Regulatory Compliance Report

Redevelopment Works Freshwater SLSC | Kooloora Ave,

Bonus Architects 15.5.2023 A

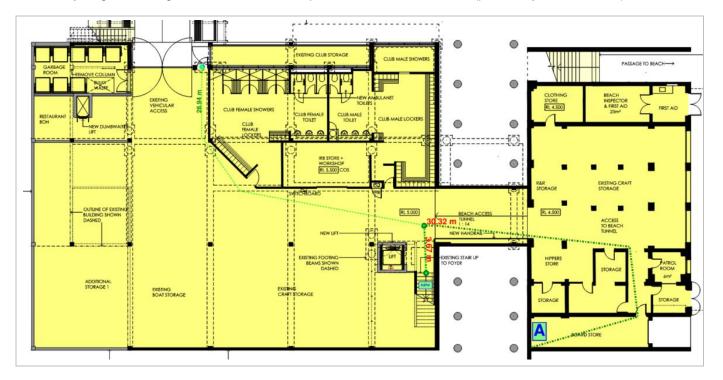
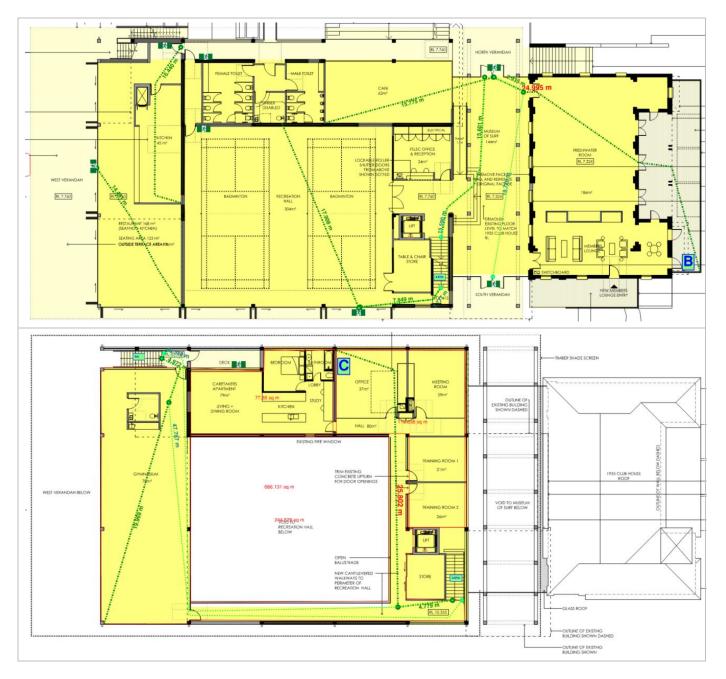
The locations of the proposed exits indicate that the travel distances within the building are as follows:

Area	BCA Provisions Assessed Distances			Comments	
	(Distance to Point of Choice/ Travel Distance/Distance Between	To a Point of Choice	Overall Travel Distance	Between Alternate Exits	
Level 1 Point A Board Store	20m/40m/60m	31m	48m	42m	2 exits are provided for Level 1 to the stairs & adjacent to the vehicular access, which creates

extended travel distances
Level 2 Point B External Balcony	20m/40m/60m	30m	33m	20m	From the external balcony and extended travel distance to a point of choice.
Level 3 Point C Office	20m/40m/60m	26m	52m	73m	The furthest office has an extended travel distance to a point of choice, overall and between the alternative exits
Caretaker's Apartment	-/6m/45m	-	6m	-	Though not shown on the drawings, it is expected the deck area will serve as an exit to the adjacent stairs within 6 m.

The above indicates that the deemed to satisfy requirements in terms of travel distances are not satisfied in 3 x areas as indicated in the markup below.

The extended travel distances and distance between the exit stairs will need to addressed to comply with the requirements of the deemed to satisfy provisions noted above, or be assessed as performance solutions by the Fire Safety Engineer using BCA Performance Requirements D1P4 and E2P2 (previously DP4 & EP2.2)
